<b>Client</b>	<b>Doveryard Limited</b>
<b>Site</b>	Oldhall
<b>Project</b>	ERF Standby Vent Stack NMA
<b>Title</b>	Planning Statement
<b>Issue Date</b>	04 January 2024

## **Planning Statement**

### **Oldhall Energy Recovery Facility – Standby Vent Stack Non-Material Amendment Application**

**Doveryard Limited**

Figure 1 Comparison of approved (left) and proposed (right) elevations. A red outline on the 'proposed' images shows the flue extension, with the orange line outlining the approved facility

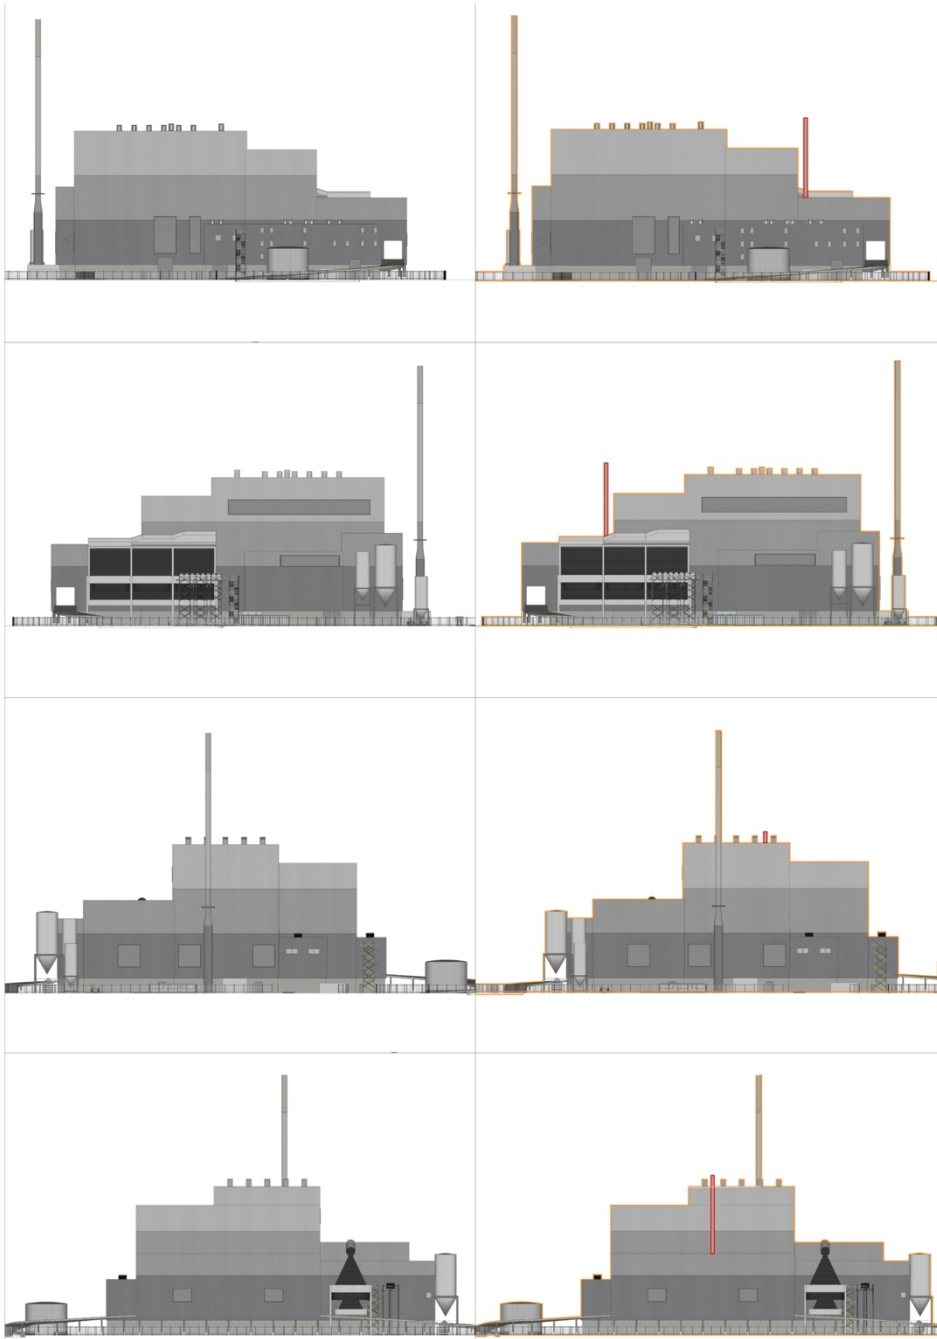
It is proposed to add a standby vent stack which would be taller than the boiler hall (the tallest building) by 3m. It would be extended in the same materials, and in the same colouring.

The only change proposed is the addition of a standby vent stack, to reach a height of 3m above the highest building – the boiler hall. It will be the same in colour as the approved and built (27m taller) main stack.
